### 3<sup>rd</sup> REVIEW COMMENT RESPONSES

Application Numbers: 28-DR-2022 & 9-PP-2022  
Project: Modus Scottsdale 6  
Project Street Address: 7801 E. San Miguel Ave., Scottsdale, AZ 85250  
Lot Square Footage: 35,411 square feet  
Zoning: R-4

**See below for images of surrounding homes within 0.25 miles.**

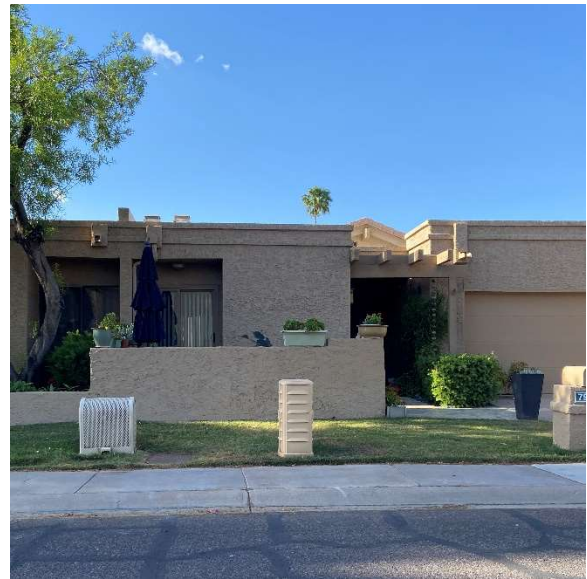
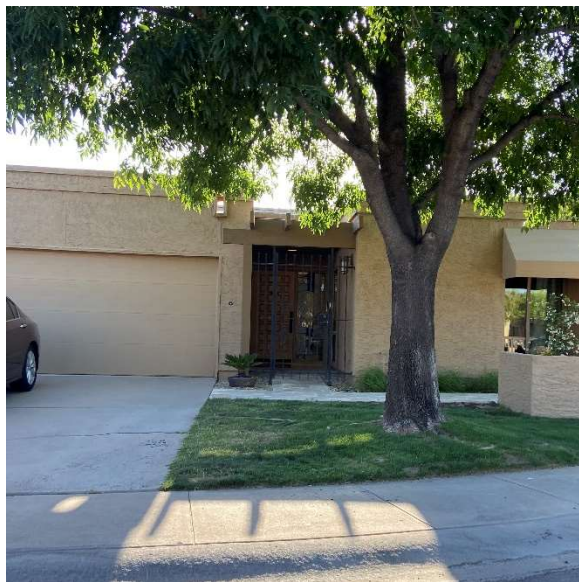
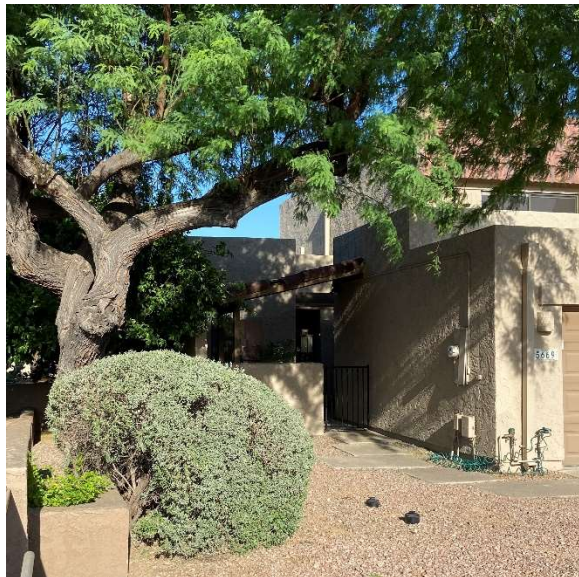
- **The elevations have been updated to match the other sheets which were correct.**
9. Regarding 1<sup>st</sup> review comment #7, it is stated that "...we are moving up the front entry gates, and making them full height..." in response to the street activation comment. Please provide clarification as to how a taller wall/gate will help with activation of the street frontage. It seems this may have the opposite effect.

7. The City's Sensitive Design Principle #1 encourages new development to enhance and strengthen the design character of the area. This Principle goes on to state "Building design should consider the distinctive qualities and character of the surrounding context and, as appropriate, incorporate those qualities in its design." And "Building design should be sensitive to the evolving context of an area over time." Although it is not the intent of these guidelines to require new development to match existing development, new development should respond to and compliment the architecture and character of the area. Additionally, the proposed site and unit layout do not appear to provide any activation of the street frontages as some of the existing townhomes in the area do with at grade outdoor patios in the front yards and front doors facing toward the street. Please revise the site plans, floor plans, and building elevations to respond to the contextual character as described.

- **To activate the street frontage on E San Miguel Ave, we are moving up the front entry gates, and making them full height (See sheet A2.8). We also incorporate sidewalks that cut through the driveways that lead to these entry gates. These characteristics respond and compliment most of the surrounding homes as they also have front facing garages, and sidewalks that lead to front doors that are set back substantially from the road. Additionally, the goal of the City Sensitive Design Principles here is to promote knowing and interacting with neighbors. This is a good idea but could be considered outmoded and is not what will likely happen because the people who will buy these townhomes will more than likely hire a landscaper and instead do their entertaining in the backyards, which will limit neighbor interactions. Therefore, a greater emphasis was placed on the backyard design as that is where most of the outside leisure time will take place. That said, our design does incorporate second level patios at each unit making our total building faced for both levels 50% patio space. The existing single-family home on the property we are developing does not have any intention of activating the street front or reflecting the surrounding context. Our development will be a major improvement in both aforementioned areas.**

- The original comment we received stated that our design needed to "respond to and compliment the architecture and character of the area" and that "the proposed site and unit layout do not appear to provide any activation of the street frontages as some of the existing townhomes in the area do with ... front doors facing toward the street". We originally had our entry gates pulled back farther between the units, almost hidden. In our current design, the front gates are pulled past the front of the building and are the height of a front door. This mimics the surrounding townhomes with front facing gates that lead to an intermediary space before you reach the actual front door.

\*Front facing entry gates. Second Level Patios. Hardscape and landscape design.
